Subject: Maine Yankee Atomic Power Company - Proposed Change
No. 158 - Radiological Effluent Technical Specifications
(RETS)

In accordance with 10 CFR 50.91(b) the State of Maine has reviewed the proposed Technical Specification change modifying the RETS by:

ATTACHMENT 1

MAINE YANKEE ATOMIC POWER COMPANY
 OFF-SITE DOSE CALCULATION MANUAL

FIGURE 2.1.

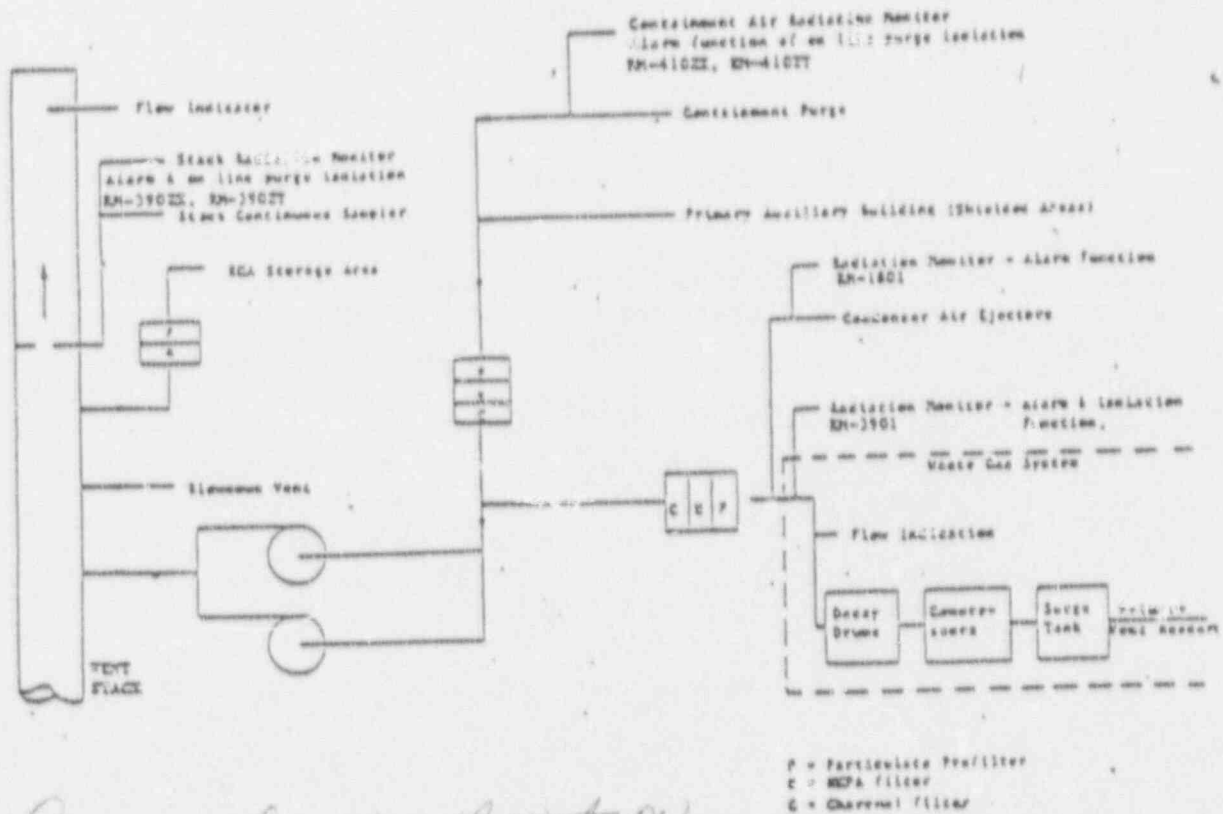
Comment here is that test on this diagram should be as legible as that of figure 6.1 on the previous page!
